COMMENT LETTER NO. 3

MEMORANDUM

Subject: Technical Assessment of the New Beatrice West Project (12553 West Beatrice Street) MND

Subject: **Response to Kimley-Horn Comment Memo
12575 Beatrice Street Office Project**

FIGURE 7-2 PROJECT TRAFFIC VOLUMES

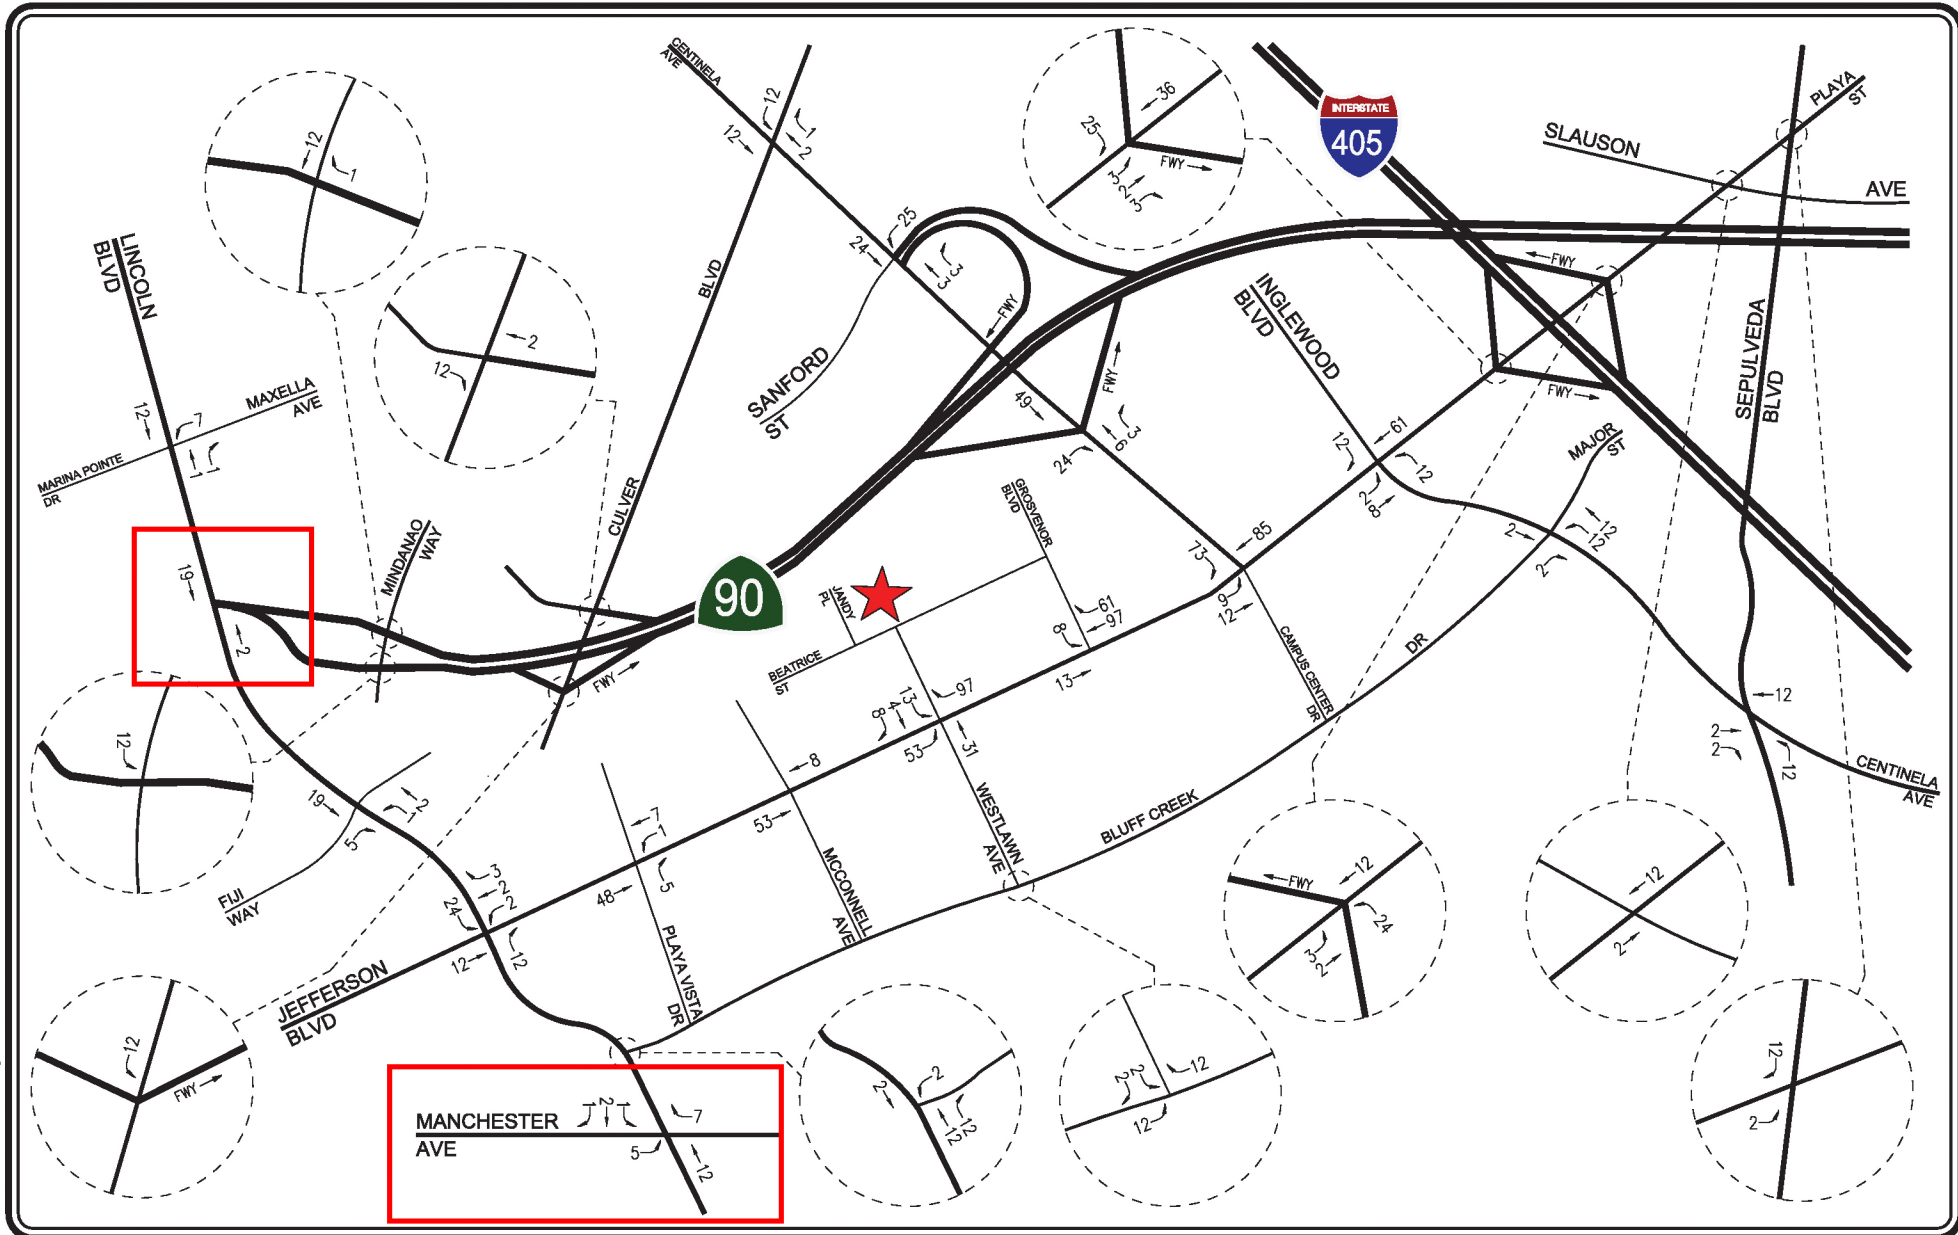
The CMP traffic impact analysis (TIA) guidelines require that intersection monitoring locations must be examined if the proposed project will add 50 or more trips to the intersection during either the A.M. or P.M. weekday peak hours. The nearest CMP monitoring stations are the intersections of Lincoln & Manchester and Lincoln & State Route 90 Expressway, located approximately 1.5 miles from the project site. As shown in Figure 7-2 and Figure 7-3 in the traffic study report, the proposed Project would only add 28 AM peak hour trips and 34 PM peak hour trips to the Lincoln Boulevard/Manchester Avenue intersection and would only add 21 AM peak hour trips and 27 PM peak hour trips to the Lincoln Boulevard/Marina Expressway (SR90) intersection. Therefore, no further review of potential impacts to intersection monitoring locations that are part of the CMP highway system is required. The nearest freeway monitoring station is located on Interstate 405 north of La Tijera Boulevard. The CMP TIA guidelines require that freeway monitoring locations must be examined if the proposed project will add 150 or more trips to the intersection during either the AM or PM weekday peak hours. Again, as shown in Figure 7-2 and Figure 7-3, the proposed project will not add 150 or more trips (in either direction) during either the AM or PM weekday peak hours to the CMP freeway monitoring location. Therefore, no further review of potential impacts to freeway monitoring locations that are part of the CMP highway system is required. A copy of the referenced Figures 7-2 and 7-3 is provided as **Attachment "D"** to this report.
